## 24.6 CHAPTER 10 - SCENIC RESOURCES

HOMEWOOD MOUNTAIN RESORT SKI AREA MASTER PLAN EIR/EIS

Figure 10-10A. SR 89 Scenic Viewpoint 1 of North Base Area – Alternative 1A.

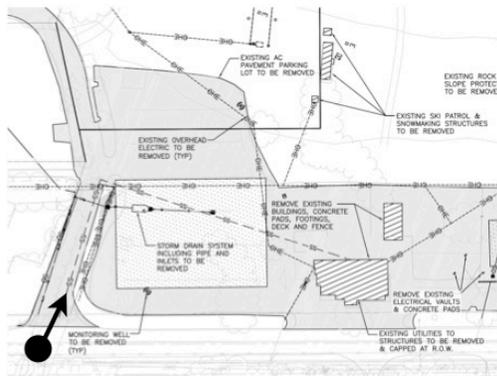
Figure 10-10A, DEIR/EIS page 10-19, FEIR/EIS page 10-20: Add simulation for Alternative 1A

Figure 10-13B. Scenic Viewpoint 1 from South Base Area – Alt 1A.

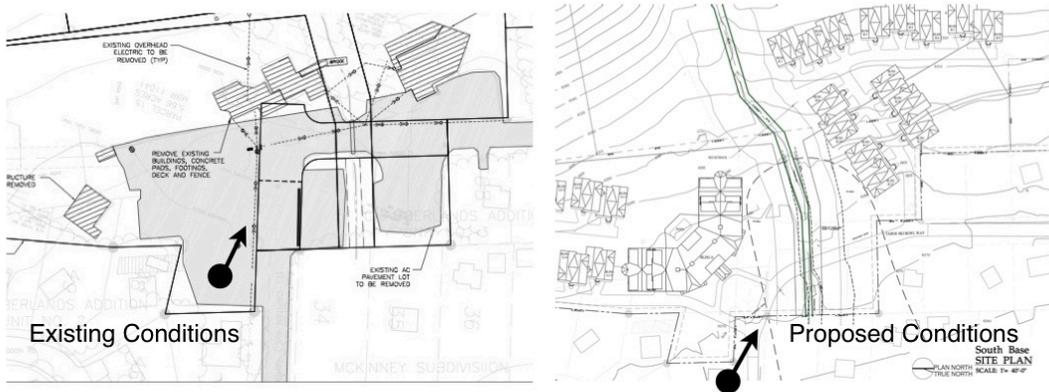
Figure 10-13B, DEIR/EIS page 10-22, FEIR/EIS page 10-24: Add simulation for Alternative 1A
